Access Compliance Report

Public Rights-of-Way

(Curb Ramps)

Intersection ID: N/A	Main Street: E_4TH_ST	Cross Street: S_CALDWELL_ST	Location: W
ADA ID: 42AF0BA8D0E8	Ramp Type: Directional2	Initial Pass/Fail: Pass	Overall Compliance: No
Severity Score: 2.5			
Codes/Mitigation Info/Possible Solution		Field Measurements/Component Compliance

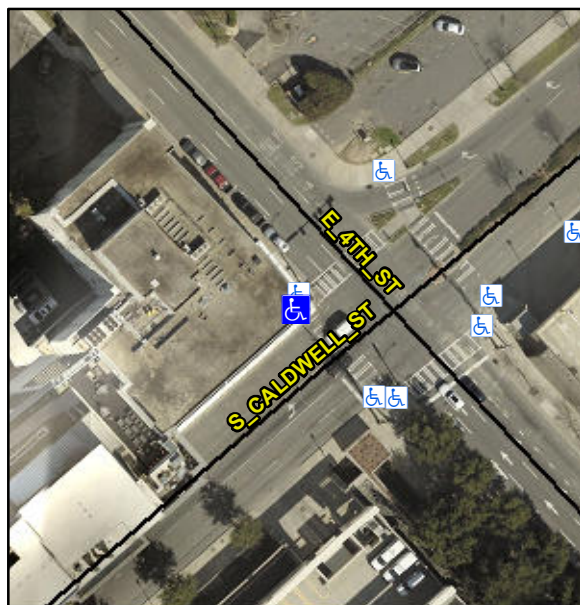
Not Found, R304.2.2-Perp, R304.3.2-Para, R304.5.3

Compliance	Description	Data	Compliance	Description	Data
N/A	Ramp Length (in)	62.0	Yes	Grade Break?	Yes
Yes	Ramp Width (in)	48.0	No	Grade Break Slope (%)	10.4
Yes	Ramp Slope (%)	4.6	Yes	Grade Break XSlope (%)	0.4
Yes	Ramp XSlope (%)	1.9			
N/A	Flare Type LT	N/A	N/A	Flare Type RT	N/A
Yes	Flare Slope LT (%)	8.6	N/A	Flare Slope RT (%)	11.5
N/A	Flare Traversable LT?	Yes	N/A	Flare Traversable RT?	Yes
Yes	Landing Length (in)	67.0	Yes	DWS Provided?	Yes
Yes	Landing Width (in)	48.0	Yes	DWS Contrast?	Yes
No	Landing Slope (%)	6.9	Yes	DWS Length (in)	37.0
Yes	Landing X Slope (%)	0.3	Yes	DWS Full Width?	Yes
N/A	Landing Curb? (Y/N)	N/A	Yes	DWS Offset LT (in)	13.0
N/A	Shared Landing?	Yes	Yes	DWS Offset RT (in)	1.0
Yes	Gutter Ponding?	No	Yes	Gutter Slope (%)	4.4
Yes	Gutter Lip Ht (in)	0.0	No	Gutter X Slope (%)	3.4
N/A	Painted X Walk1?	Yes		Road Slope (%)	2.2
	X Walk 1 Direction	To SE		Road X Slope (%)	2.4
	X Walk 1 Width (in)	120.0		Clear Space?	Yes

**Remove & Replace Entire Ramp.
Remove & Replace Gutter.**
